NL-09-0172

May 19, 2009

> Edwin I. Hatch Nuclear Plant Joseph M. Farley Nuclear Plant Vogtle Electric Generating Plant License Amendment Request for Adoption of TSTF-511, Rev. 0, Eliminate Working Hour Restrictions from TS 5.2.2 to Support Compliance with 10 CFR Part 26

Markup for HNP Proposed TS Change

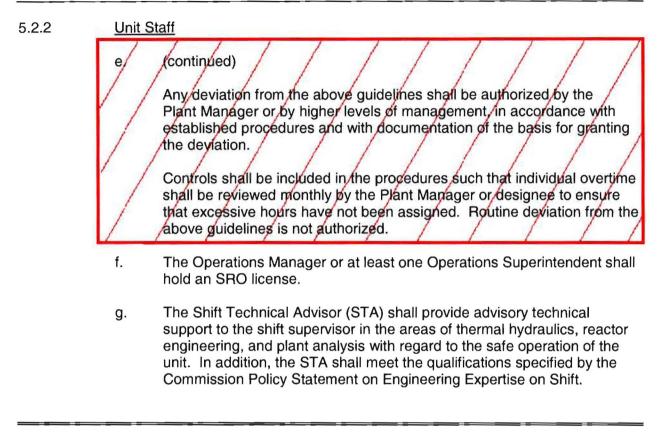
Deleted

Administrative procedures shall be developed and implemented to limit the working hours of unit staff who perform safety related functions (e.g., licensed and non-licensed operations personnel, health physics technicians, key maintenance personnel, etc.).

Adequate shift coverage shall be maintained without routine heavy use of overtime. The objective shall be to have operating personnel work a nominal 40 hour week while the unit is operating. However, in the event that unforeseen problems require substantial amounts of overtime to be used, or during extended periods of shutdown for refueling, major maintenance, or major plant modification, on a temporary basis the following guidelines shall be followed:

- 1. An individual should not be permitted to work more than 16 hours straight, excluding shift turnover time;
  - An individual should not be permitted to work more than 16 hours in any 24 hour period, nor more than 24 hours in any 48 hour period, nor more than 72 hours in any 7 day period, all excluding shift turnover time;
  - A break of at least 8 hours should be allowed between work periods, including shift turnover time;
- 4. Except during extended shutdown periods, the use of overtime should be considered on an individual basis and not for the entire staff on a shift.

Markup for FNP Proposed TS Change

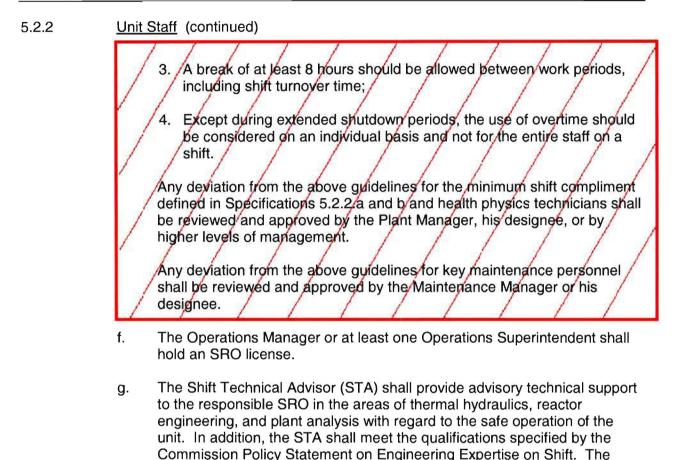
Deleted

- e. Administrative procedures shall be developed and implemented to limit the working hours of unit staff who perform safety related functions (e.g., licensed SROs, licensed ROs, health physicists, auxiliary operators, and key maintenance personnel).

Adequate shift overage shall be maintained without routine heavy use of overtime. The objective shall be to have operating personnel work a nominal 40 hour week while the unit is operating. However, in the event that unforeseen problems require substantial amounts of overtime to be used, or during extended periods of shutdown for refueling, major maintenance, or major plant modification, on a temporary basis the following guidelines shall be followed:

- 1. An individual should not be permitted to work more than 16 hours straight, excluding shift/turnover time;
- 2. An individual should not be permitted to work more than 16 hours in any 24 hour period, nor more than 24 hours in any 48 hour period, nor more than 72 hours in any 7 day period, all excluding shift turnover time:
